Annual Monitoring Report

Monitoring Year 5 of 7

Poplin Ridge Stream Restoration Project

RE: Poplin Ridge Stream Restoration Site: MY5 Monitoring Report (NCDMS ID 95359)

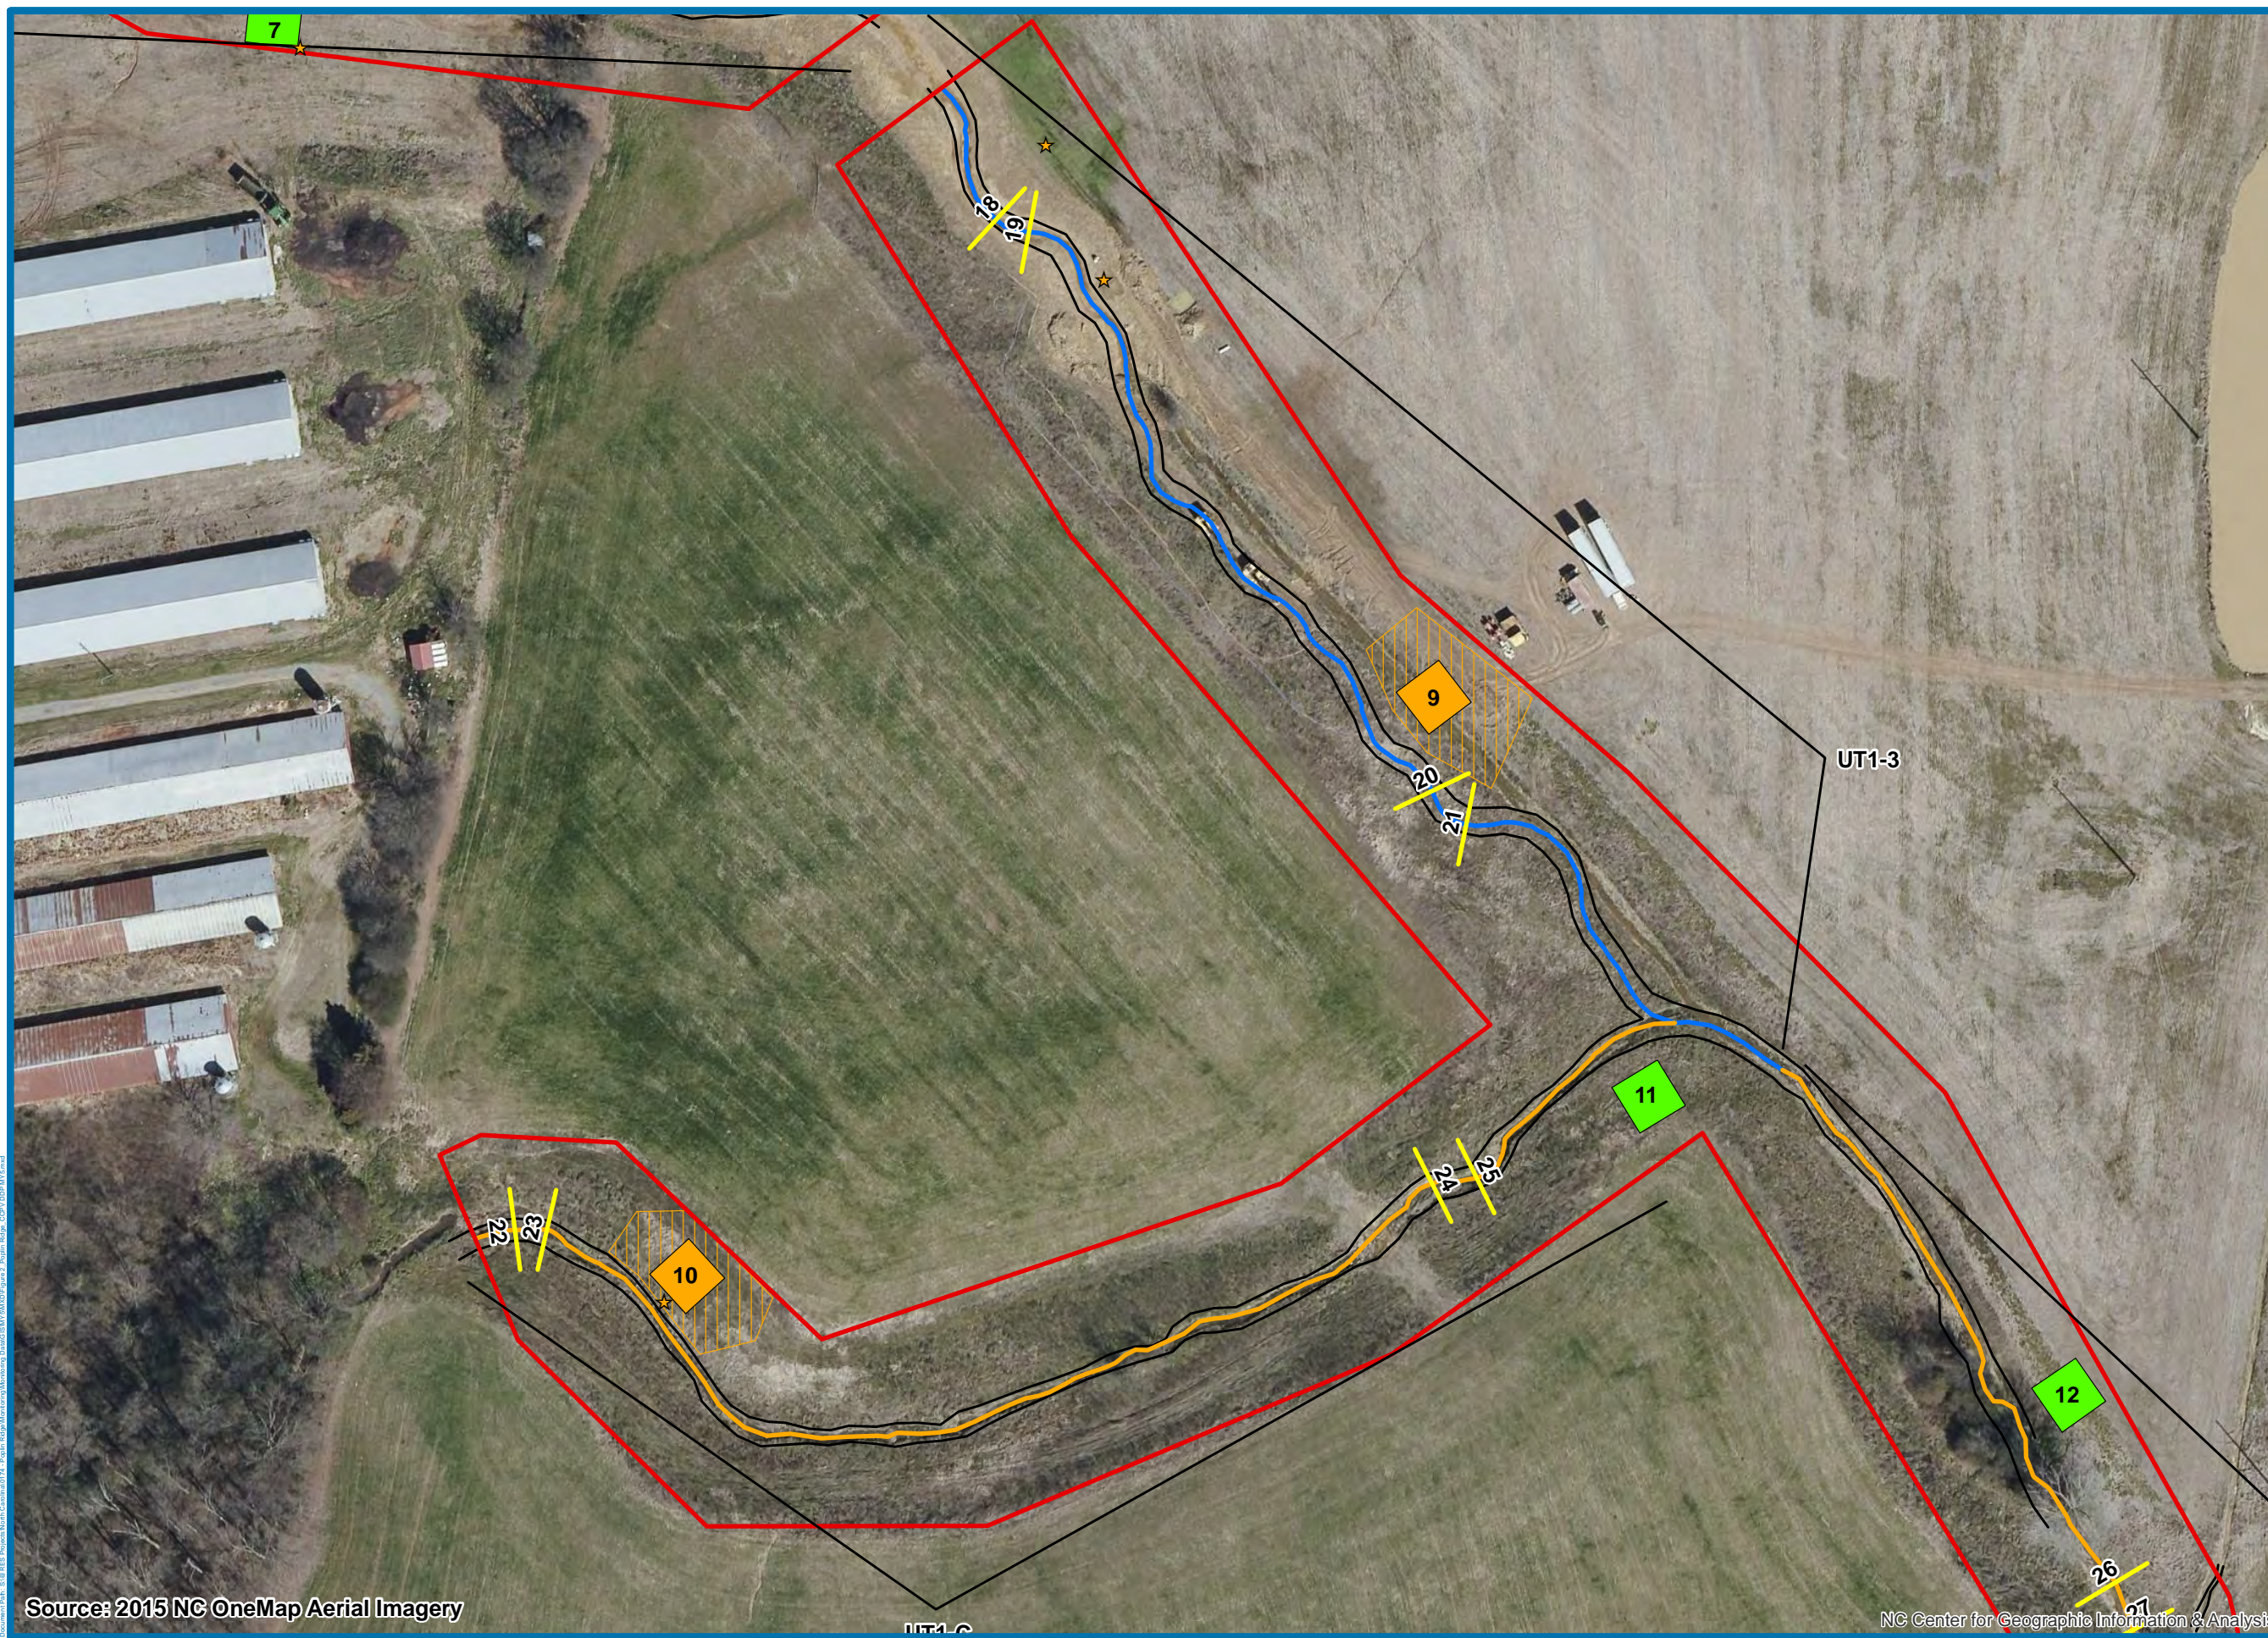
CCPV Sheets: The vegetation plot section of the CCPV legend indicates a 320 planted stem per acre success (green vs. orange). The success criteria in MY5 is 260 planted stems per acre in MY5. DMS recommends updating the sheet legends accordingly.

CCPV Sheets and Table 6: The Poplin Ridge site has had significant exotic invasive populations in previous monitoring years. No exotic invasive treatments appear to have been completed in MY5 (2019). Additionally, no invasive areas are shown on the CCPV maps. Please confirm that current invasives on the site are beneath the mapping threshold (1,000 SqFt) or revise the CCPV map and Table 6 accordingly.

Done.

Invasive species treatments were not administered in 2019. Follow up treatments will be performed in 2020.

MY5 2019 Poplin Ridge UT2-A Flow Gauge

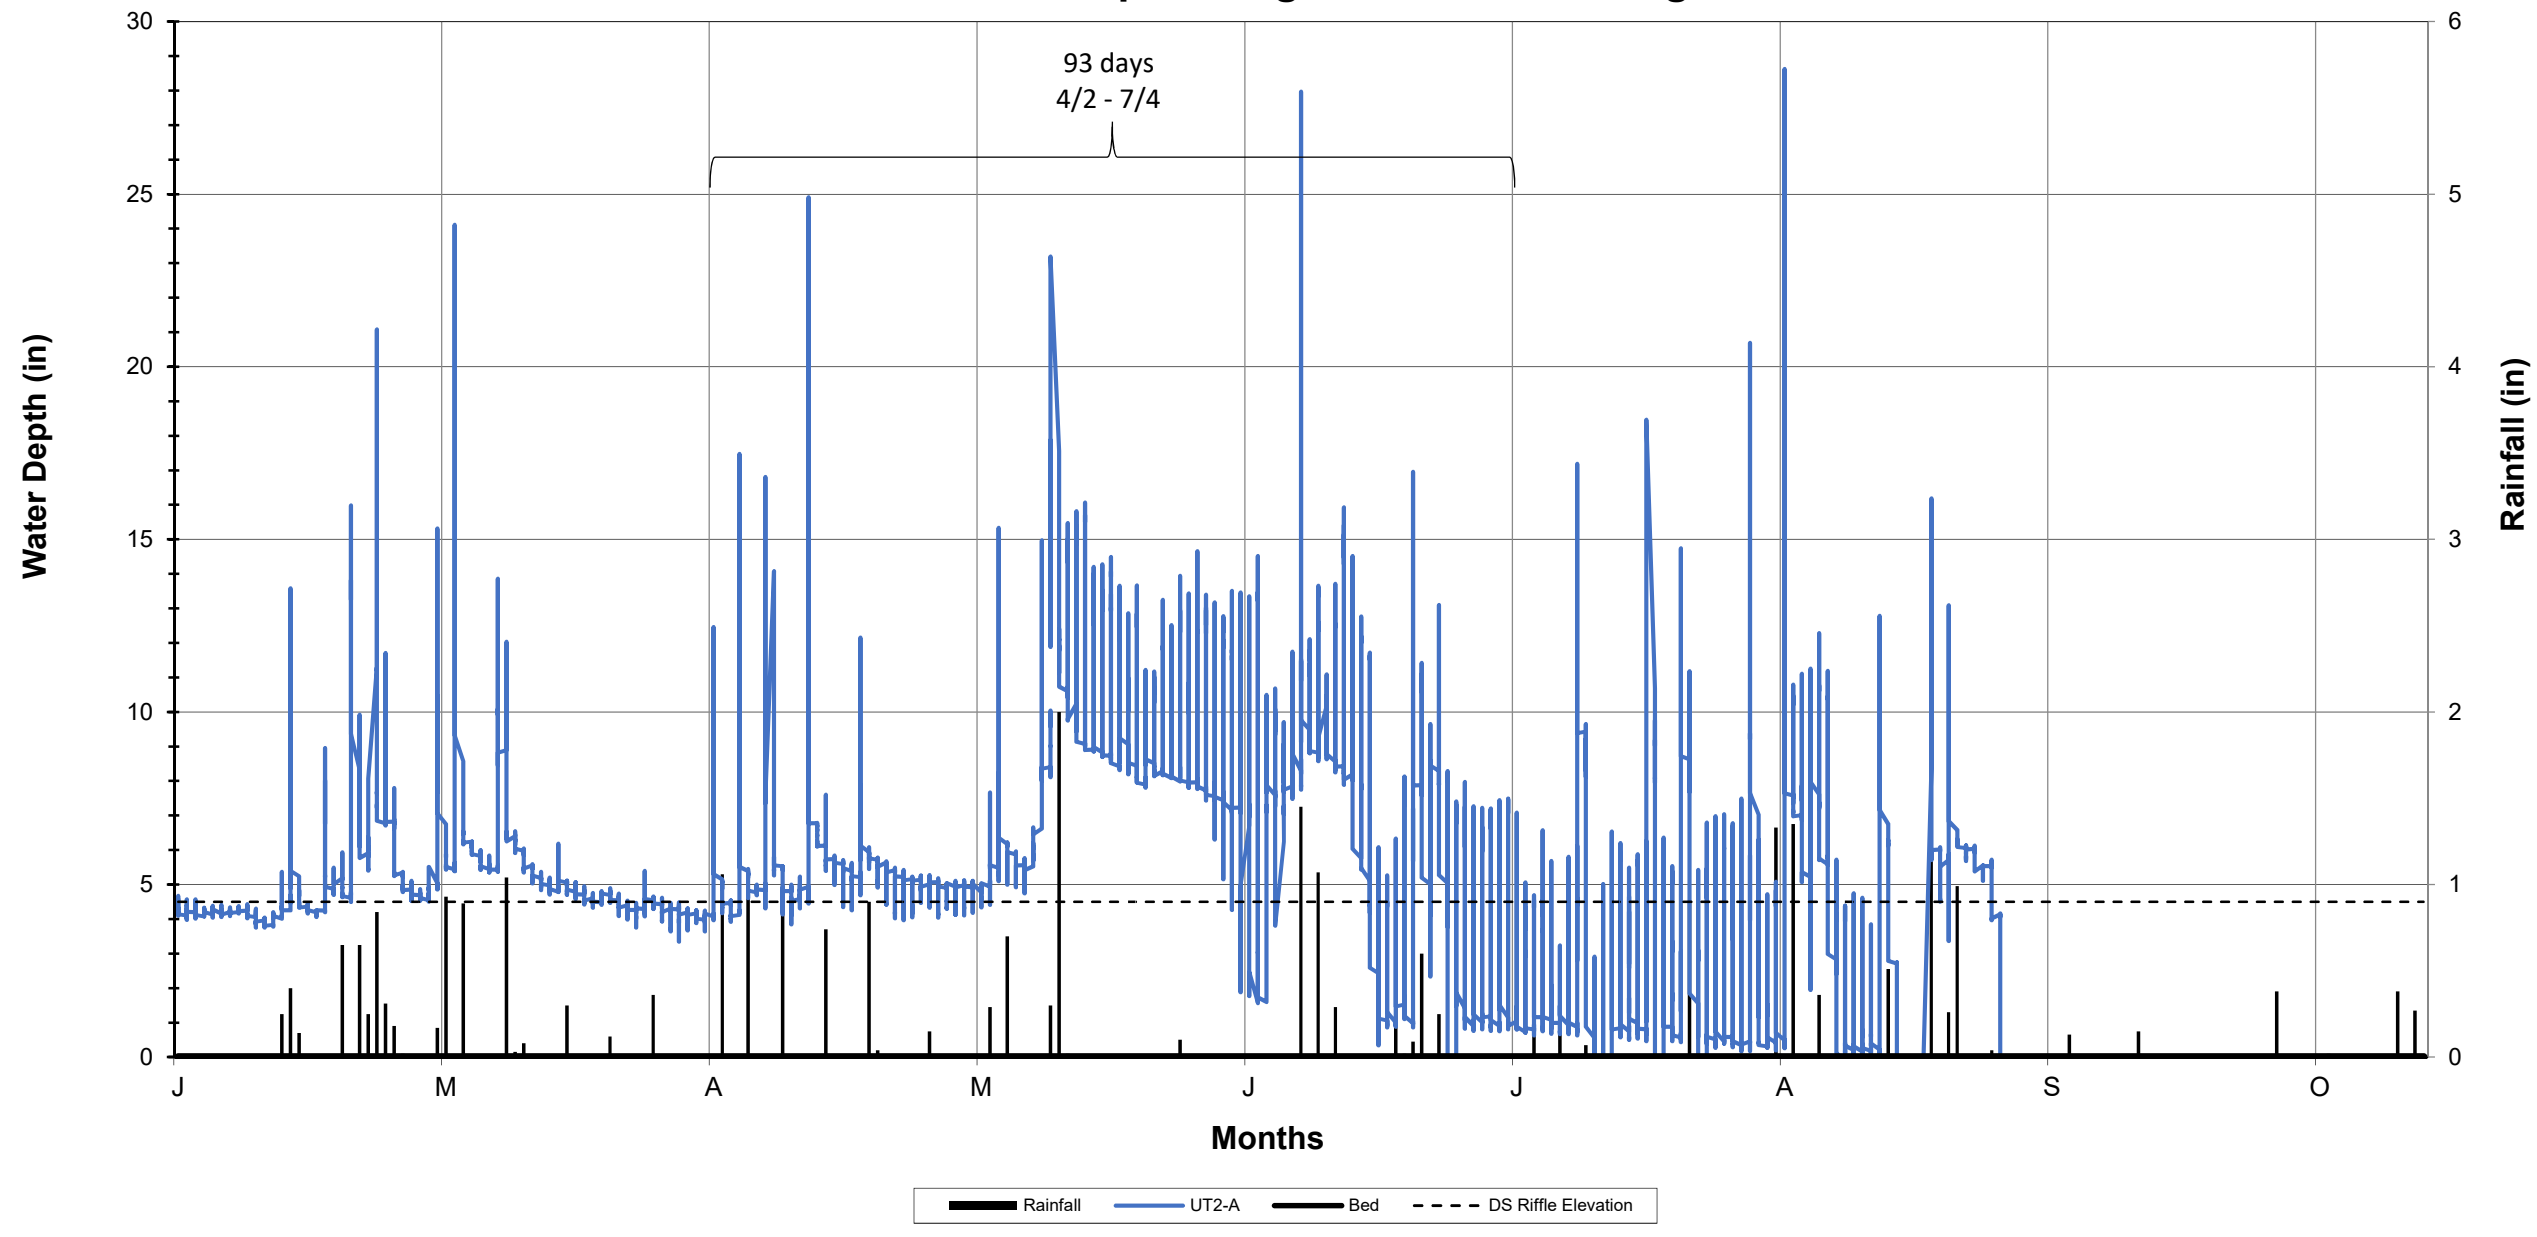
Chart - MY5 2019 Poplin Ridge UT-2A Flow Gauge – Please add a call out showing the 93 consecutive flow days reported.

Done.
